COMMENTS ON THE PROPOSAL FOR A GTR ON MOTORCYCLE CONTROLS,
TELL-TALES AND INDICATORS

Note: The text reproduced below was prepared by the expert from the European Commission in order to give comments on informal document GRSG-96-34 as well as document ECE/TRANS/WP.29/2006/74 which has served as the basis of the Commission's remarks. The European Commission wishes to note that all efforts made to achieve a Global Technical Regulation regarding this subject are regarded as very welcome.

Brake:

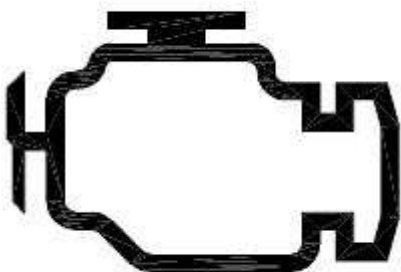
Also the following optional symbol for any other braking failure (Red) should be added:

JUSTIFICATION: This is the universal symbol for general braking failure (other than ABS failure) and should therefore be added (i.e. not a required function, but to be used if such tell-tale is present).

Emissions related Malfunction Indicator Lamp (Yellow)

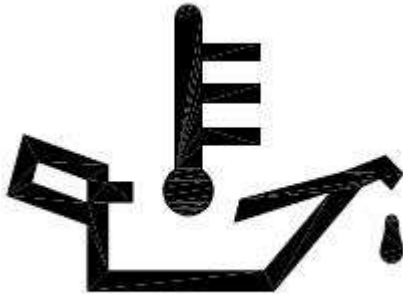
This (or any similar) symbol shall not be used to convey non-emissions related failures or operation states.

JUSTIFICATION: An emissions related error is not dangerous and therefore the colour of the tell-tale should not be red. Such MILs are already widely used and vary between different manufacturers. The Commission's opinion is that this symbol should be added.

Symbols for further consideration

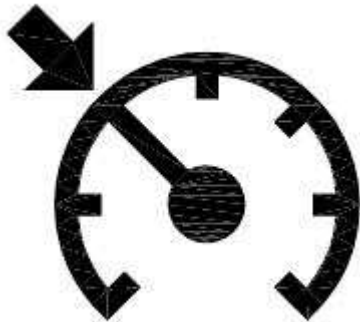
"If _____ fitted, it shall be identified by the given symbol:"

Oil temperature (Red)

Vehicle speed control (Yellow or Green)

Tyre pressure (Yellow or Red)

Service (reminder) indicator (Yellow)

JUSTIFICATION: For further harmonization purposes.
